**Modified Proposed Plan  
for Soil and Dry Sediment at the  
RVAAP-01 Ramsdell Quarry Landfill**

**Ravenna Army Ammunition Plant  
Ravenna, Ohio**

**DRAFT MODIFIED PROPOSED PLAN FOR SOIL AND DRY SEDIMENT AT THE RVAAP-01 RAMSDELL QUARRY LANDFILL  
RAVENNA ARMY AMMUNITION PLANT, RAVENNA OHIO  
COMMENT RESPONSE TABLE ~ REVISION 0**

Figure 3. RQL Site Features and Fencing Extent Under Alternative 8

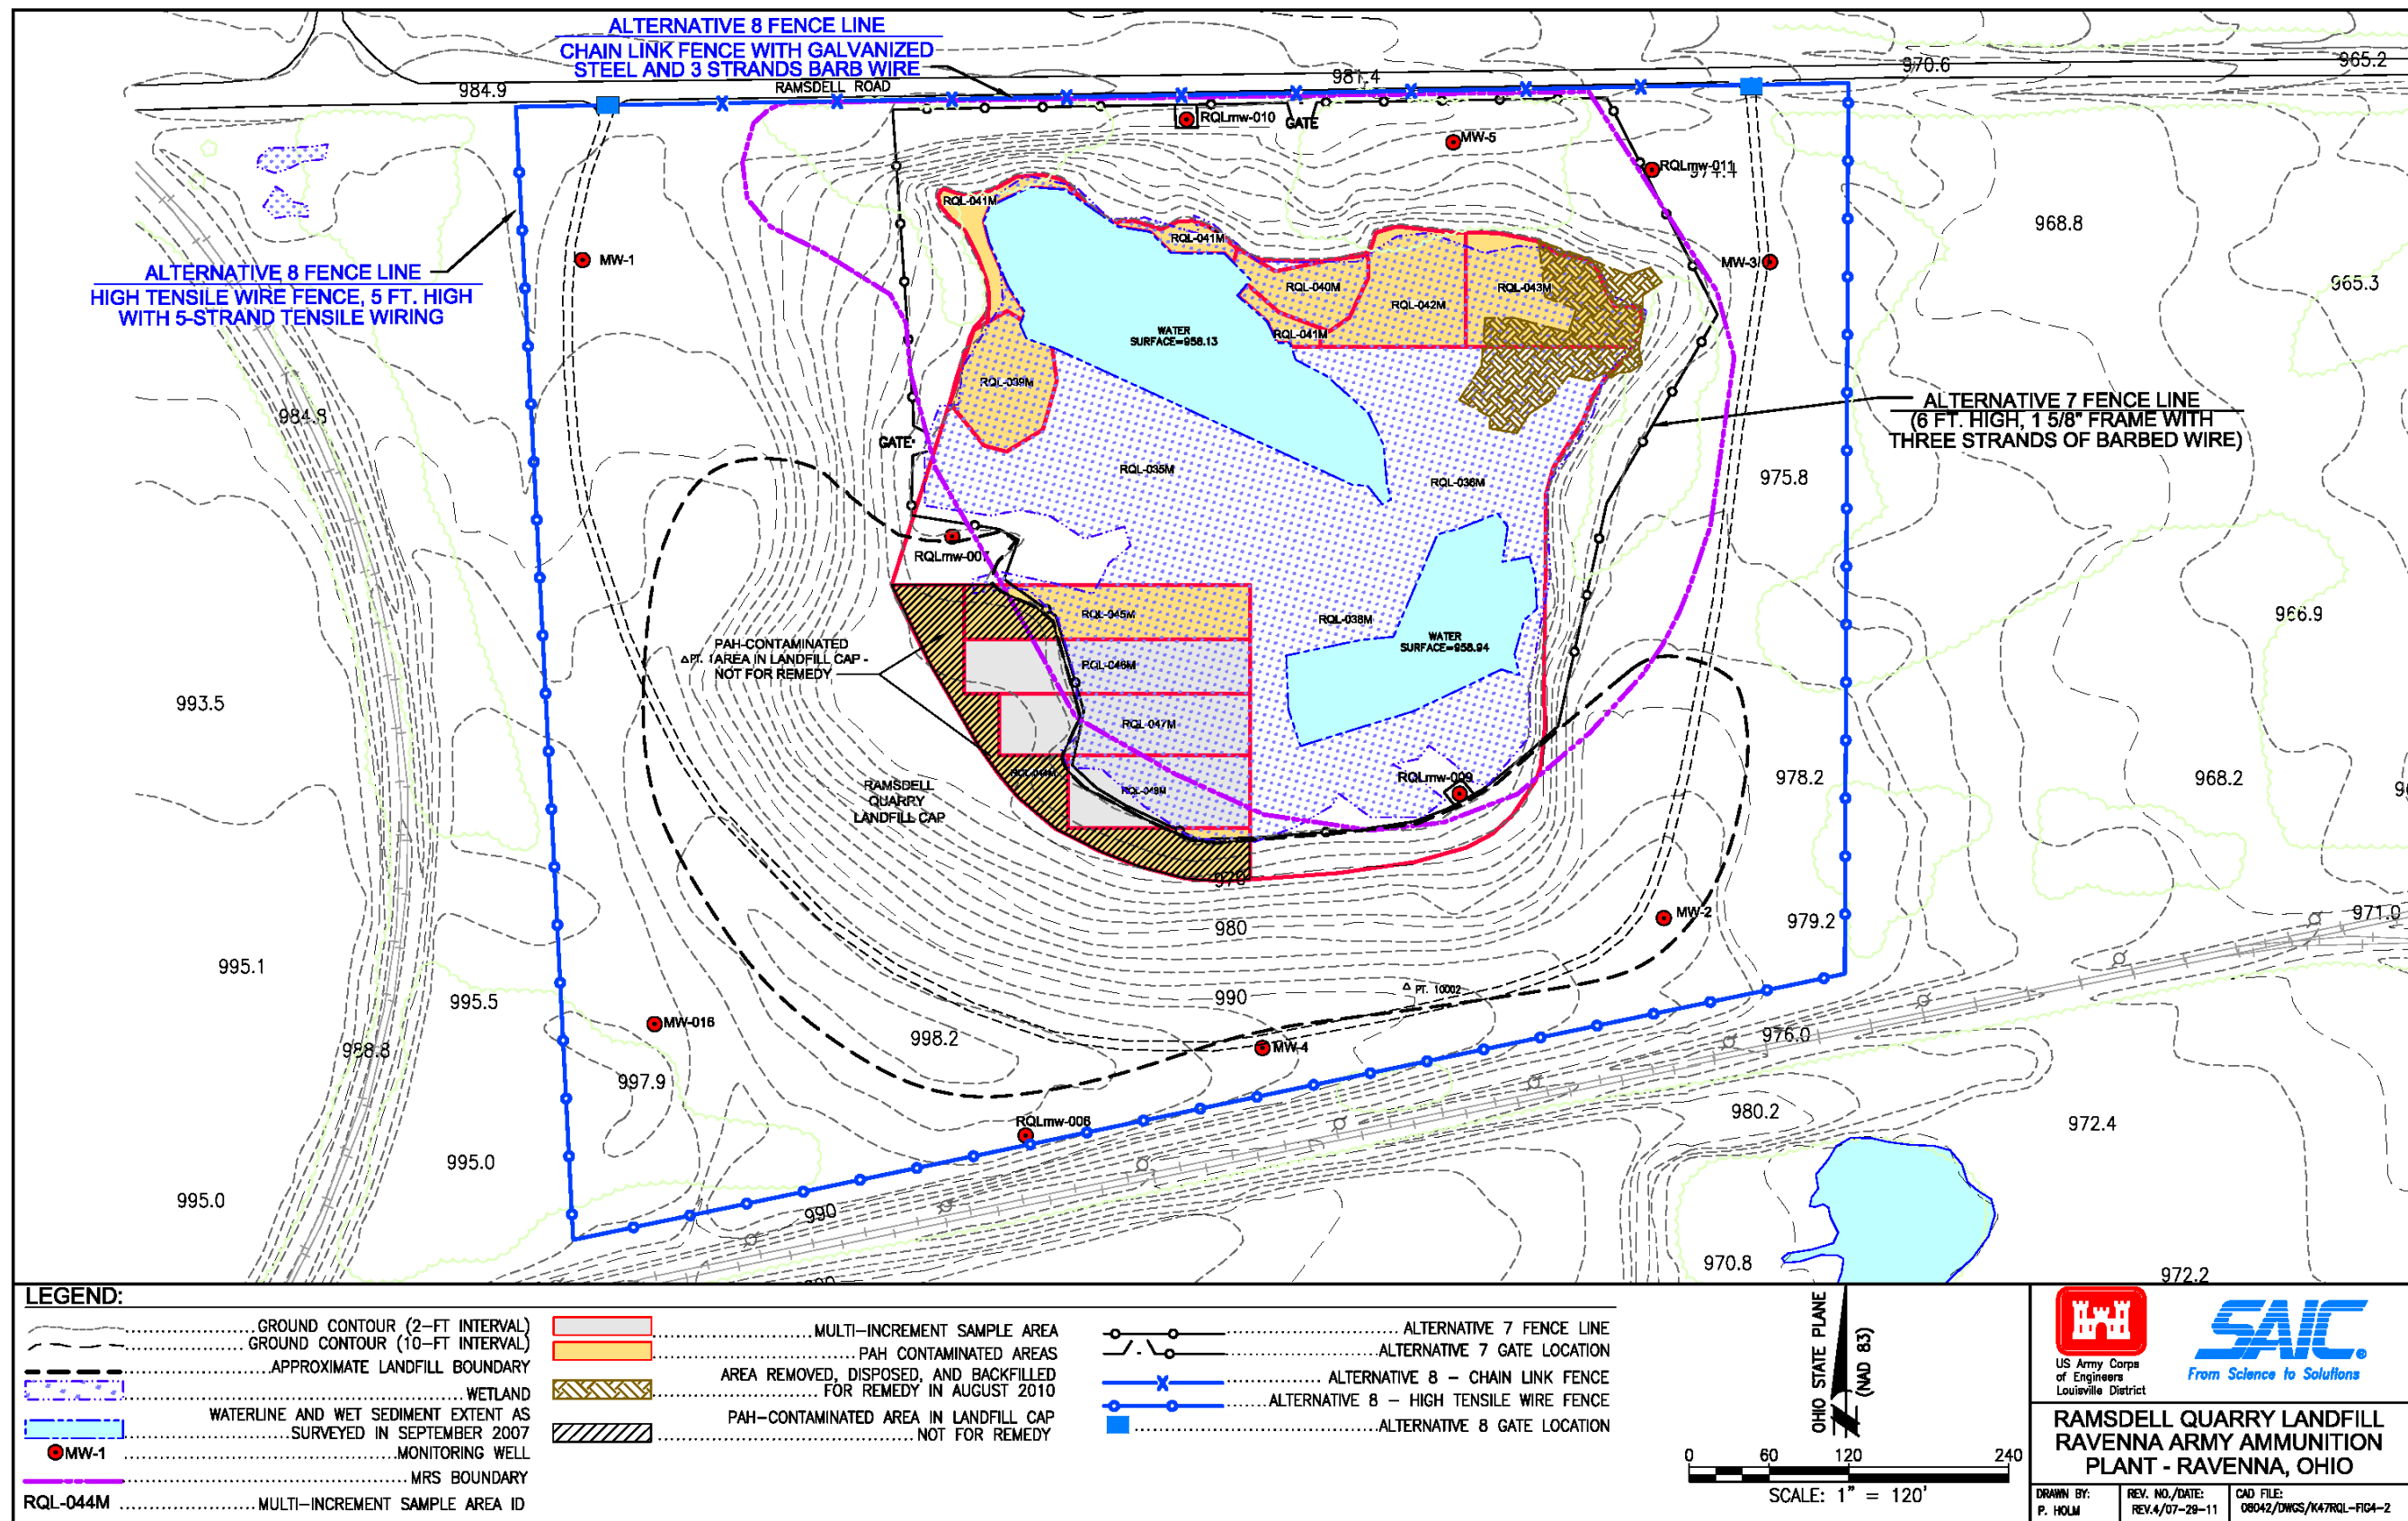
| Comment Number                  | Page or Sheet                       | Comment  | Recommendation   | Response   |
|---------------------------------|-------------------------------------|--|--|--|
| O-2.                            | Page 4, Line 20                     | There is a Figure 3, but no Figure 3-1.  | Please revise the text.  | Agree. Text has been revised to say “Figure 3”.  |

| Comment Number | Page or Sheet                | Comment  | Recommendation   | Response   |
|----------------|------------------------------|--|--|--|
| A-4.           | Page 4<br>Lines 4 -5         |  | Add to the parentheses caption as follows: “(RQL-039M and RQL-040M; See Figure - 3)”   | Agree. Text has been revised as recommended.   |
